VECTRA

February 16, 1994
RA94011

Subject: Amendment to QA Program No. 0192

FIGURE 1-1
ORGANIZATION CHART
VECTRA

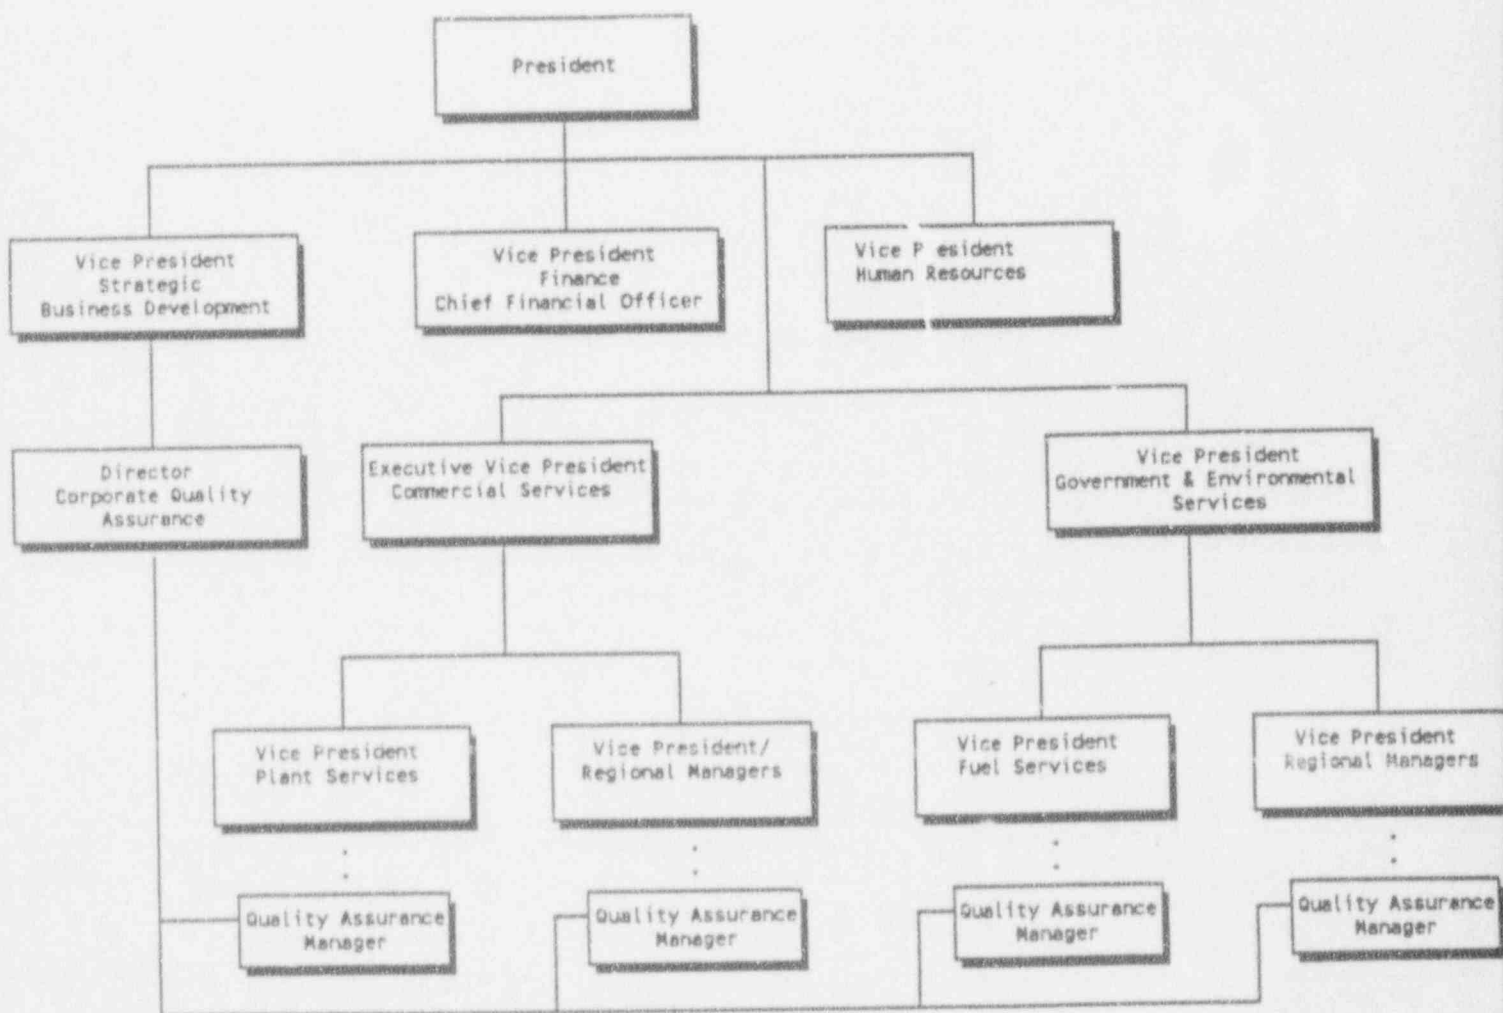
1. Change the Company name to VECTRA Technologies, Inc. (VECTRA)
2. Replace Figures 1, 2 and 3 organization charts with the enclosed, respectively. These figures show the new VECTRA organization and operating structure (service organizations) for the company.
3. Change "Material Review Board" to "Review Board". The functions and responsibilities for the Review Board remain the same; only the name was changed.
